Town of Garrett Park

To: Mayor and Town Council
From: Barbara B. Matthews, Town Manager
Subject: Town Hall Renovation
Date: November 12, 2024

Background

POTENTIAL PLAN- REUSING REAR ADDITION SHELL

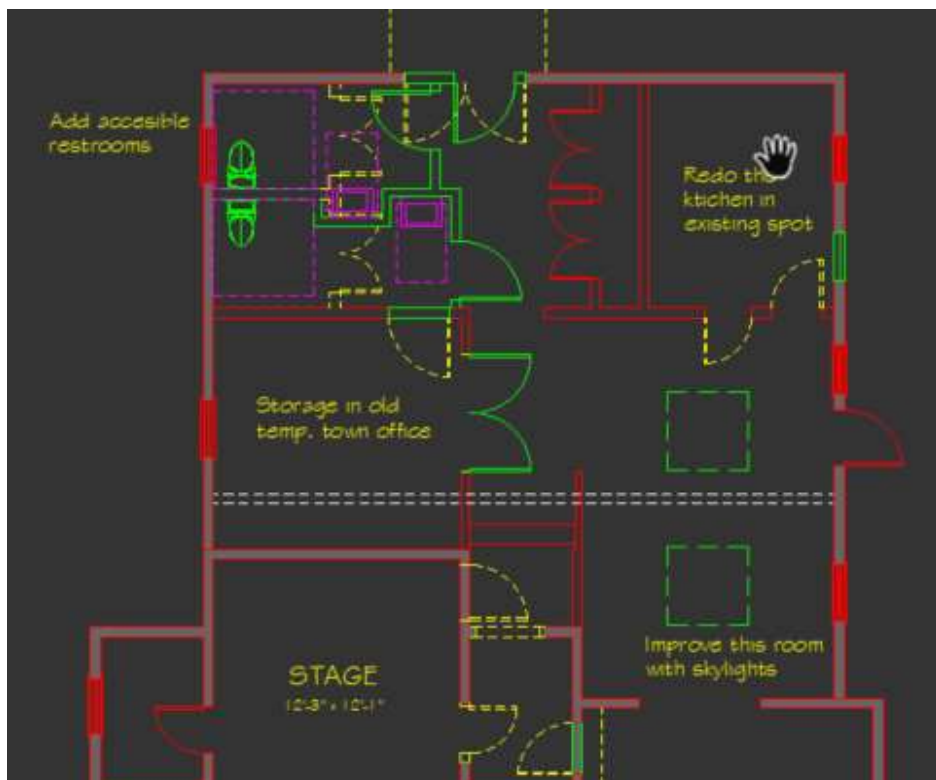
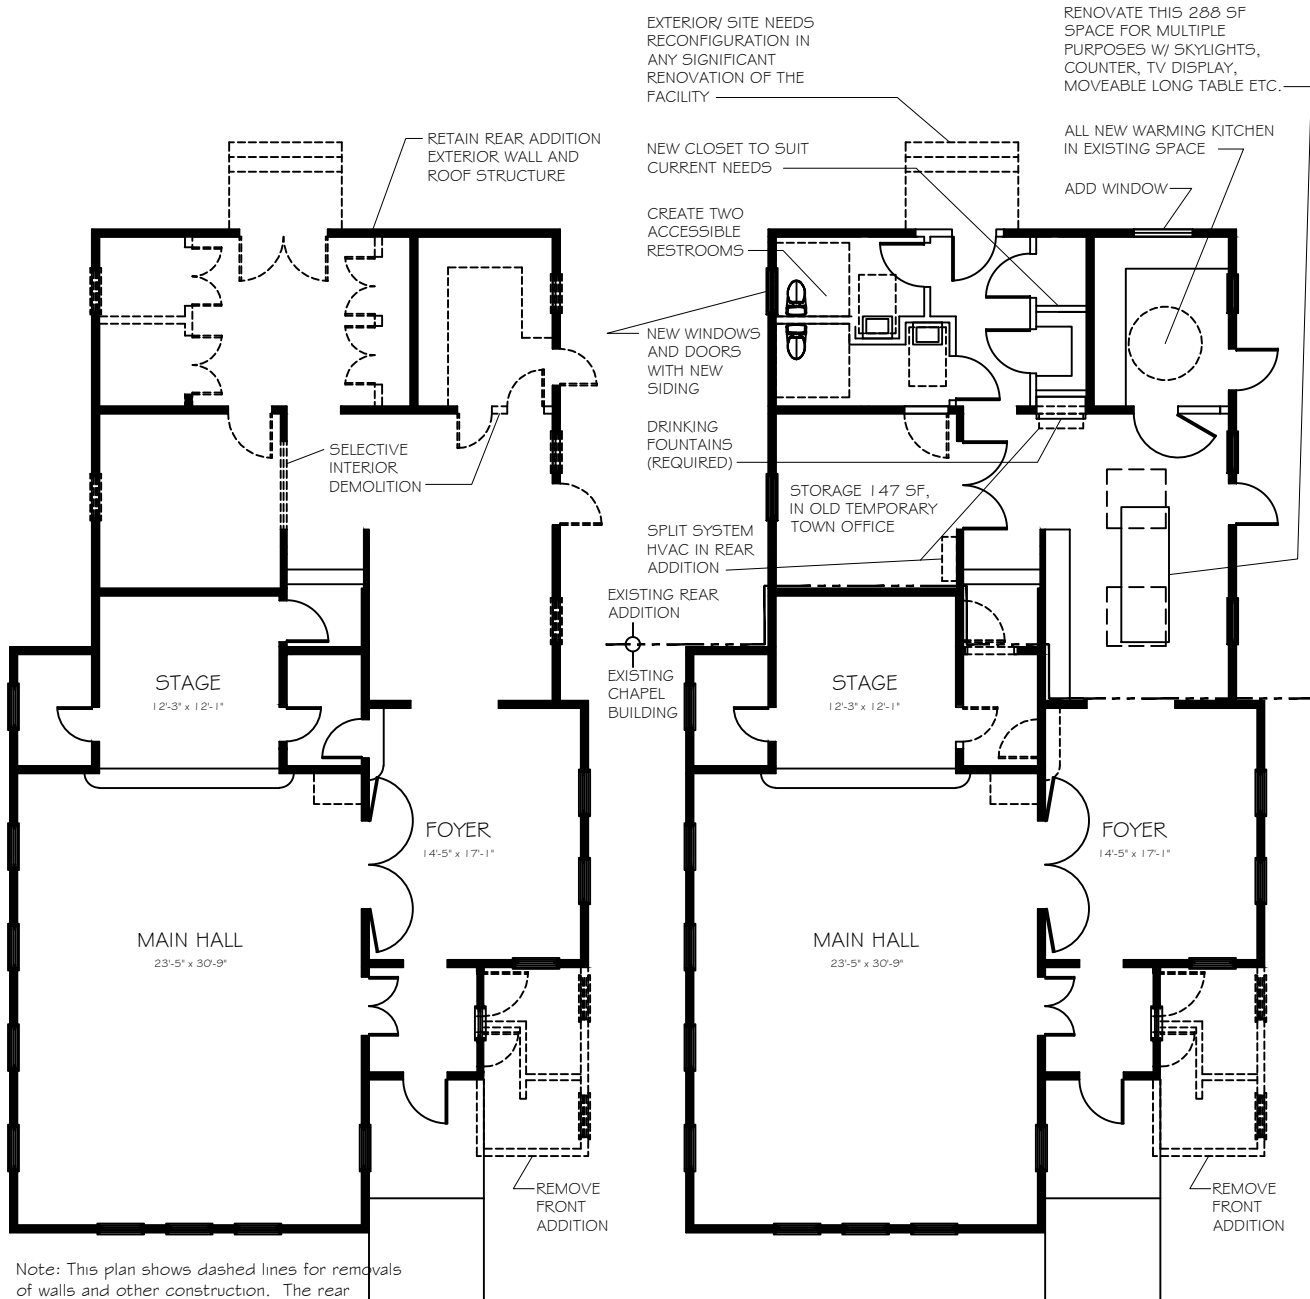
The big cost driver in the total costs is the new addition in the back. It's estimated near \$1,300 per square foot versus the restoration/renovation of the historic building, with a potentially much improved appearance, feel, and historical accuracy running roughly half that at \$670 per foot. The disparity in those numbers just doesn't sit well with me. It doesn't make any sense to spend lavishly beyond the main hall, the historic facades, the bell tower etc., and to have that additional spending be mostly on bathrooms, storage, and circulation. It was a mistake to let Wiedemann not study use of the existing shell as an alternate. Most of their assumptions or reasons to not consider reusing the rear addition shell didn't hold up past 1 or 2 questions. The spaces have code compliant height and retooling of wood framed structures of that era is fairly routine. It would be required if the addition was historic building fabric. It's not historic, but it's not a hard addition to deal with unless there's a structural deficiency, water damage, or other surprise lurking that hasn't been seen. If something like that is ever found, the town would have to punt and go new construction. I cannot imagine how the reuse of the rear addition structure couldn't cut the cost for the rear area in half, at the least, if structure is found acceptable after gutting it. With a total gut renovation of that shell, inside and out, many future visitors would end up assuming it was added on totally new. Such savings could also have the upside of a leading into a potential future addition of a larger accessory meeting space of 400 square feet or more, tacked onto the back of the building (if there's funding and demand for such an addition years out from completion of the historic building and a renovation of the rear addition with service spaces in it). Fitting accessible restrooms into the existing back addition could be done by using the room with the double back doors. Storage can continue to leverage the old temporary town office, just with a revamped layout to suit current needs. With this approach, there's a whole lot less demolition and construction, which could mean a whole lot less cost.

In the plan below, red is existing, yellow dashed is demo, and green is new. It's a pretty workable retrofit to get accessible restrooms in, and the accessory room we already use is 244 versus the 233 square feet proposed in Option 4, for a whole lot less cost. I'd like to take a half a million dollars or potentially much more in savings and spread that taxpayer contribution to other amenities in town that more residents will use as much or more than Town Hall.

Note: This plan shows dashed lines for removals of walls and other construction. The rear addition would be gutted to the structure, inside and outside, with all exterior and interior finishes replaced with new. The exposed shell would be reconfigured for plumbing, electrical, mechanical, data, insulation, general repairs, etc..
